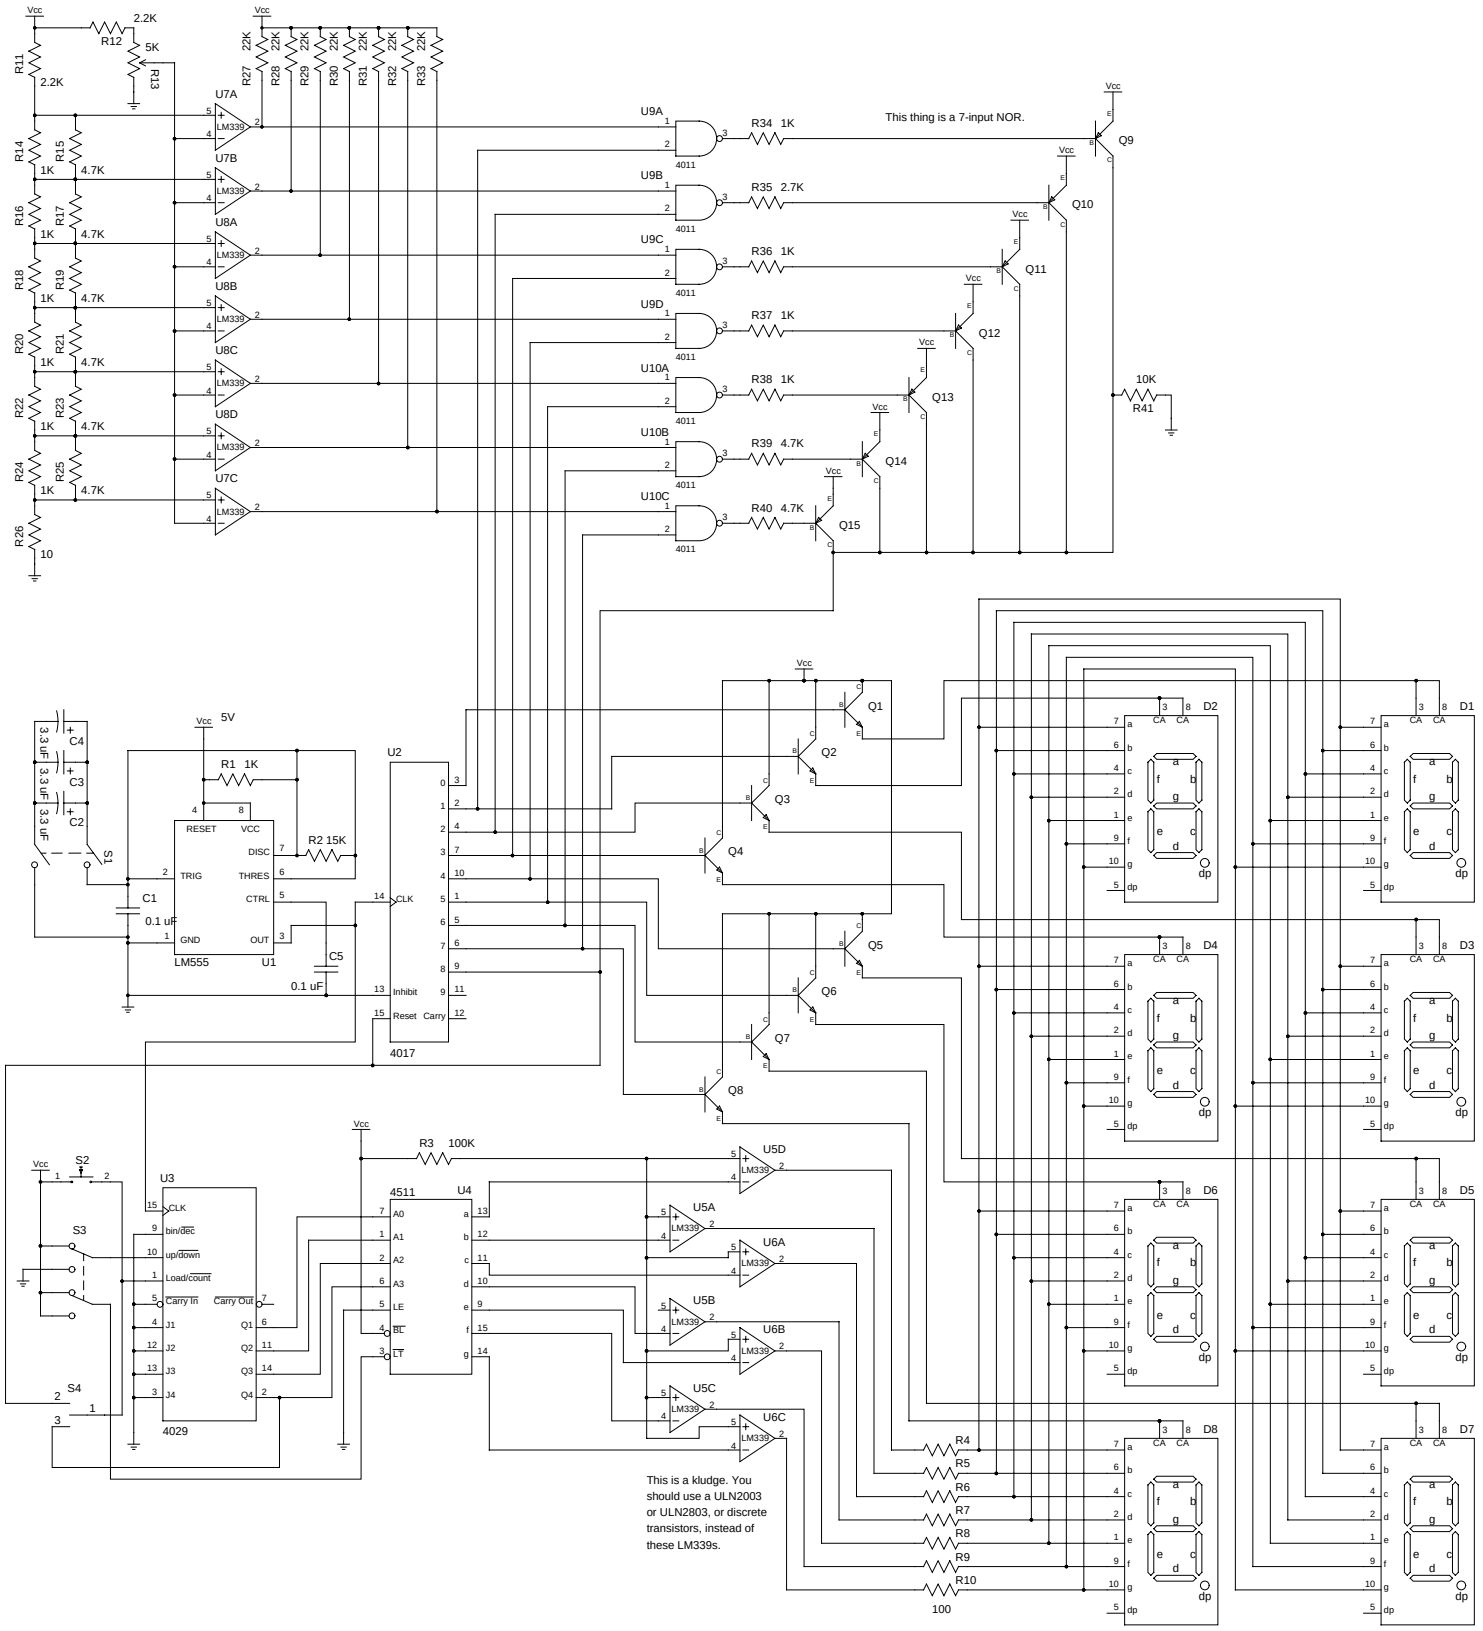
This thing is a 7-input NOR.
This is a kludge. You should use a ULN2003 or ULN2803, or discrete transistors, instead of these LM339s.
LM555
4017
4029
4511
4011
LM339
Vcc
5V
